Access Compliance Report

Public Rights-of-Way

Intersection ID: 15799	Main Street: MARION_PL	Cross Street: MELBOURNE_CT	Location:	N
ADA ID: 0083B8F69B86	Ramp Type: PerpDiag	Initial Pass/Fail: Fail	Overall Compliance: No	Severity Score: 12.5

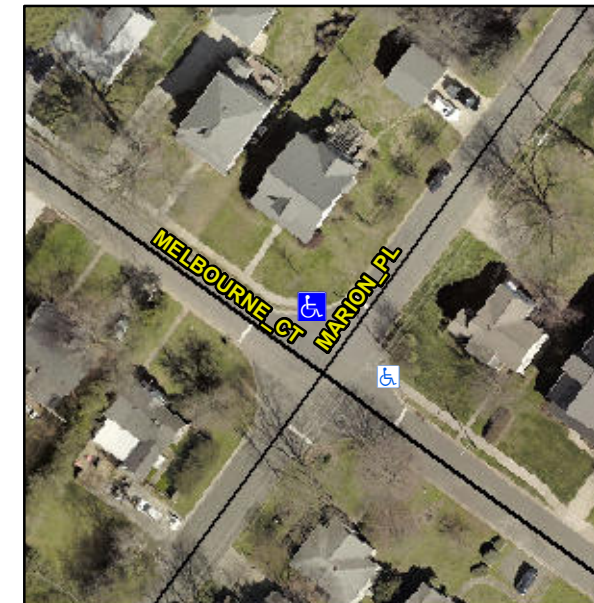
Not Found, R304.2.2

Compliance	Description	Data	Compliance	Description	Data
N/A	Ramp Length (in)	25.0	No	Ramp Slope (%)	9.0
Yes	Ramp Width (in)	48.0	Yes	Ramp XSlope (%)	0.5
N/A	Flare Type LT	N/A	N/A	Flare Type RT	N/A
N/A	Flare Slope LT (%)	N/A	N/A	Flare Slope RT (%)	N/A
N/A	Flare Traversable LT?	N/A	N/A	Flare Traversable RT?	N/A
N/A	Landing Length (in)	N/A	N/A	DWS Provided?	N/A
N/A	Landing Width (in)	N/A	N/A	DWS Contrast?	N/A
N/A	Landing Slope (%)	N/A	N/A	DWS Length (in)	N/A
N/A	Landing X Slope (%)	N/A	N/A	DWS Full Width?	N/A
N/A	Landing Curb? (Y/N)	N/A	N/A	DWS Offset (in)	N/A
N/A	Shared Landing?	N/A			
N/A	Gutter Ponding?	N/A	N/A	Gutter Slope (%)	N/A
N/A	Gutter Lip Ht (in)	N/A	N/A	Gutter X Slope (%)	N/A
N/A	Painted X Walk1?	No	N/A	Painted X Walk2?	No
	X Walk 1 Direction	To SW		X Walk 2 Direction	To SE
N/A	X Walk 1 Width (in)	N/A	N/A	X Walk 2 Width (in)	N/A
	X Walk 1 Slope (%)	0.7		X Walk 2 Slope (%)	2.8
	X Walk 1 X Slope (%)	1.9		X Walk 2 X Slope (%)	0.9

Remove & Replace Curb Ramp With Two New Directional Ramps or Equivalent.
